LORSON RANCH EAST FILING NO. 2

A PORTION OF THE SW 1/4 SECTION 13, AND OF THE SE 1/4 SECTION 14, AND A REPLAT OF TRACT E OF PIONEER LANDING AT LORSON RANCH FILING NO. 2, ALL IN TOWNSHIP 15 SOUTH, RANGE 65 WEST OF THE SIXTH PRINCIPAL MERIDIAN, EL PASO COUNTY, COLORADO

FINAL PLAT
LORSON RANCH EAST
FILING NO. 2
JOB NO. 70-065
DATE PREPARED: 10/29/2018
DATE REVISED:

PCD FILE NUMBER SF-18-019

SHEET 1 OF 8

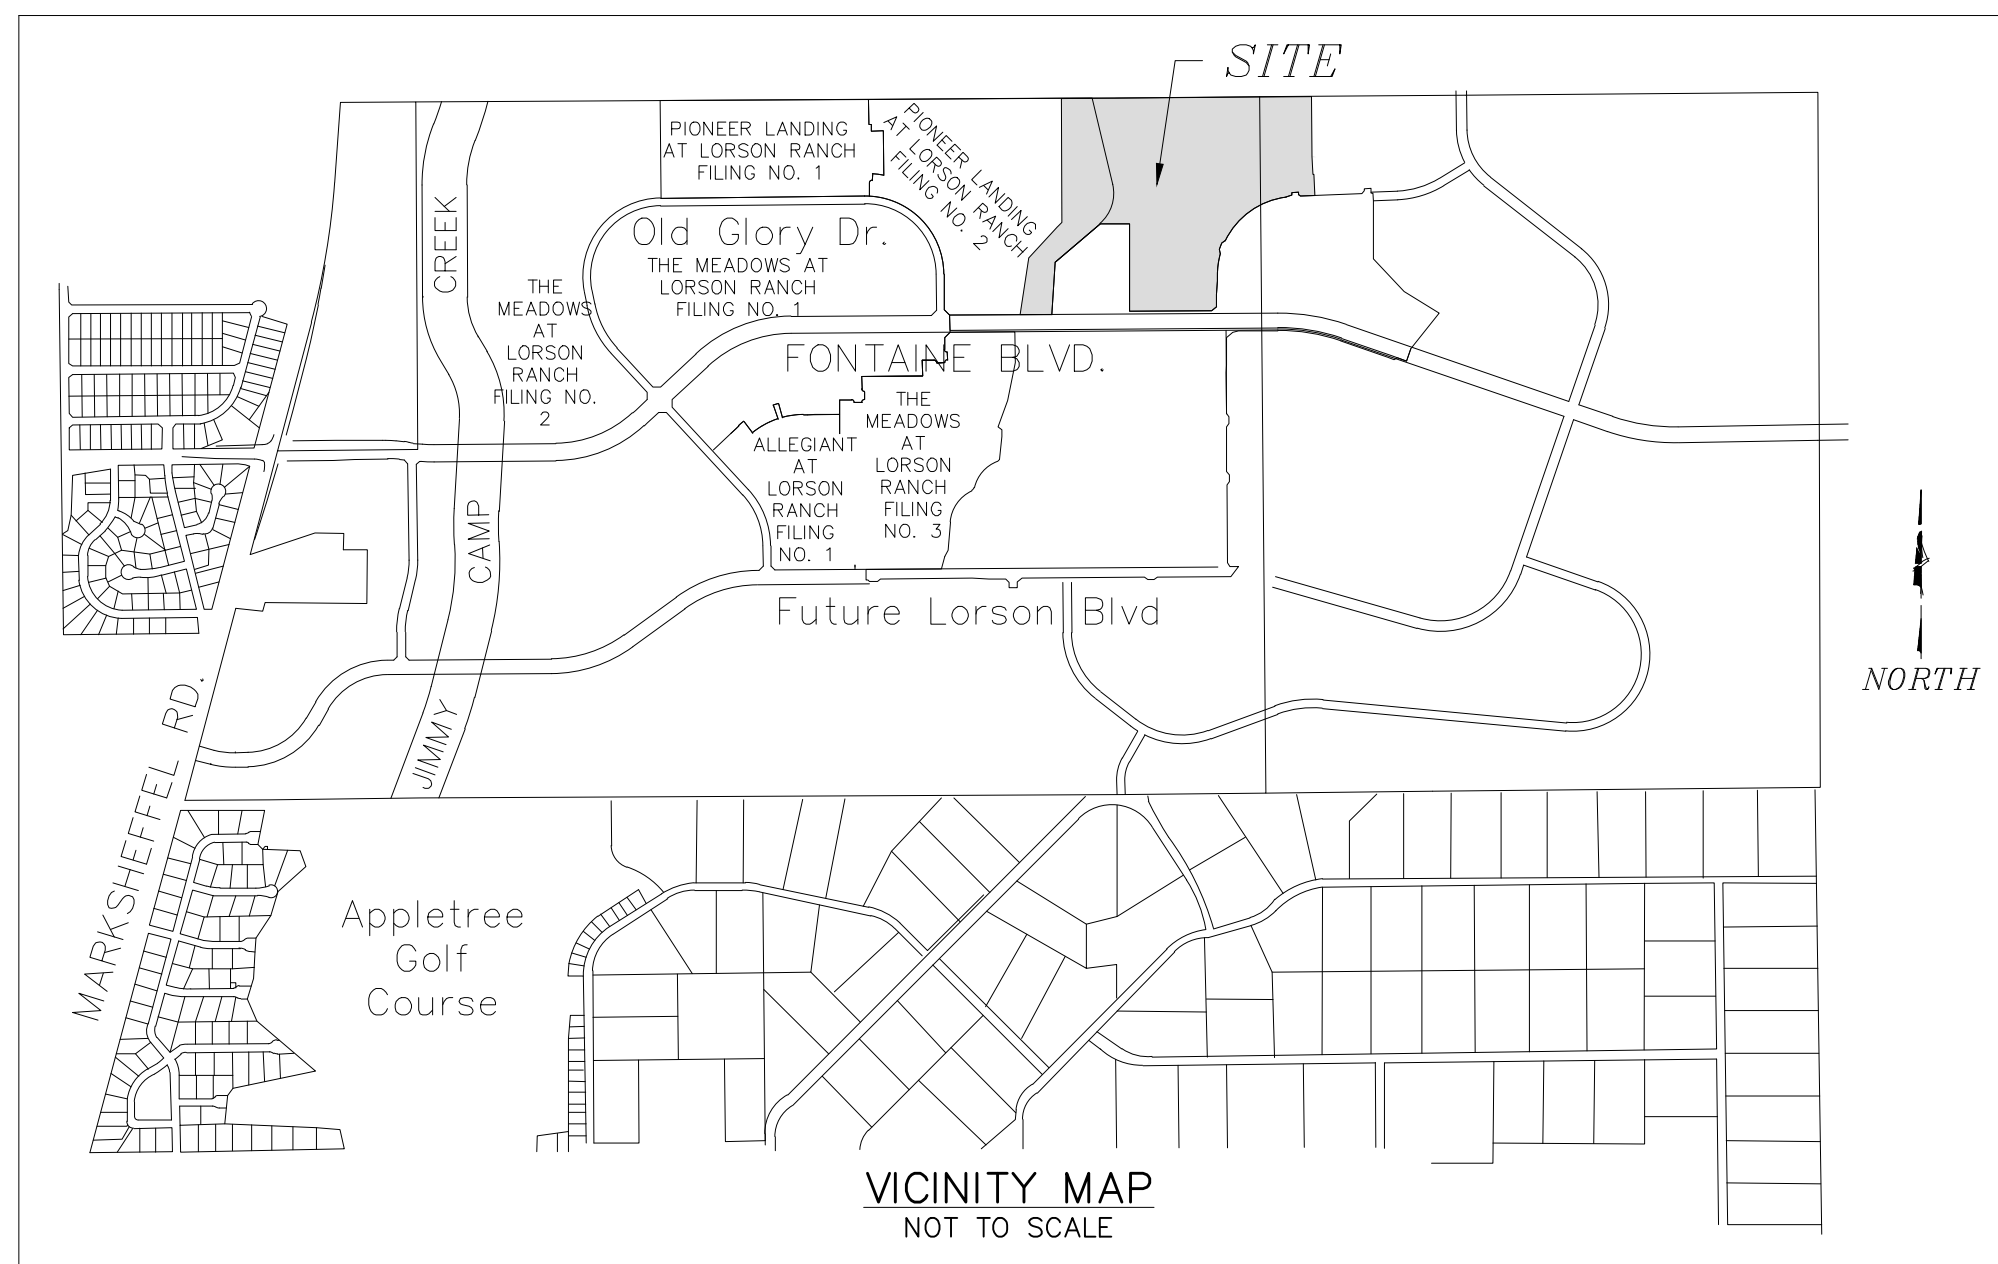
replace all 2018 with
2019? (When will
LOMR be complete?)
